THE CITY OF NEW YORK
DEPARTMENT OF DESIGN AND CONSTRUCTION
INFRASTRUCTURE DIVISION
BUREAU OF DESIGN

ADDENDUM NO. 1

DATED: March 23, 2009

SECTION A-A
 DETAILS - PROTECTIVE TREE BARRIER

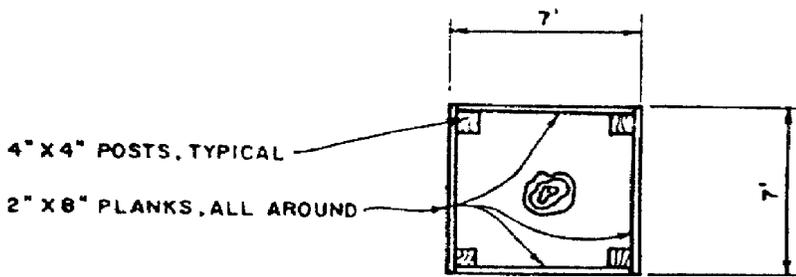
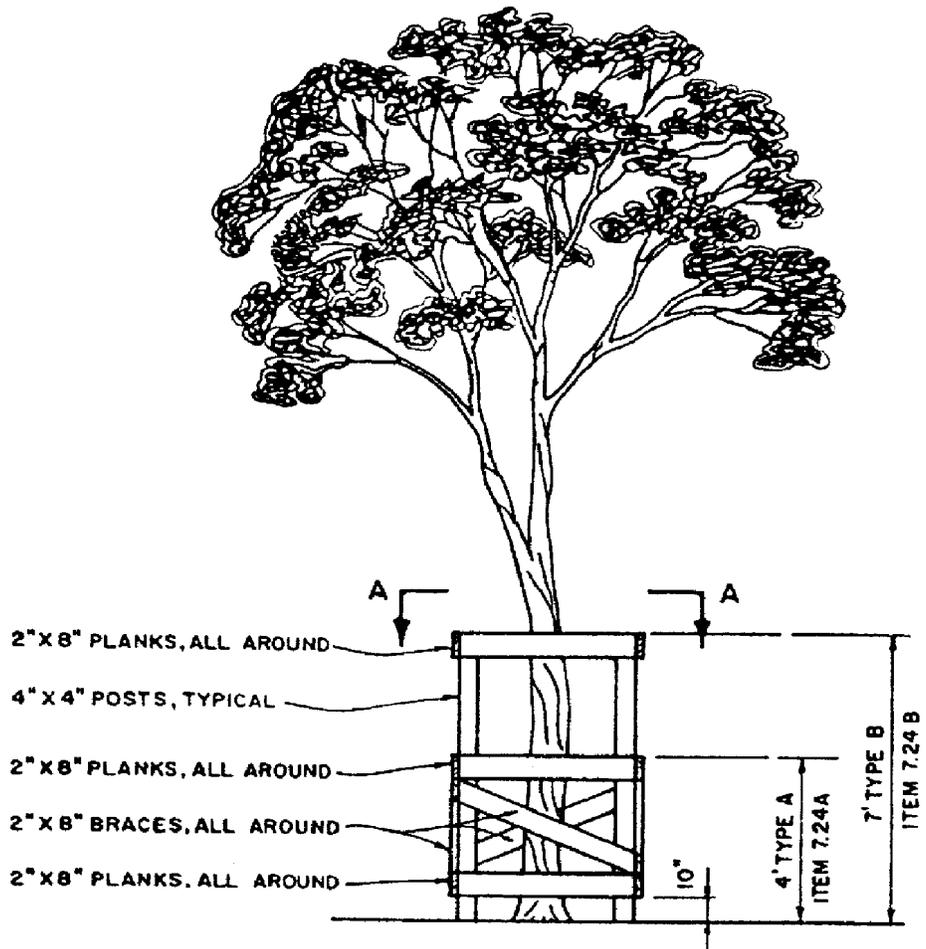
4. Refer to Page 263, **Subsection 4.22.4.**, first paragraph, second and third lines;
Delete in the first paragraph, the second and third lines beginning with the words "on the New York City Department of Transportation's Standard Details of Construction . . ." in their entirety;
Substitute the following text: "on the following sketch and as directed by the Engineer."

5. Refer to Page 265;
Delete in words "(NO TEXT ON THIS PAGE)";
Substitute the sketch contained on the following page A1-1b.
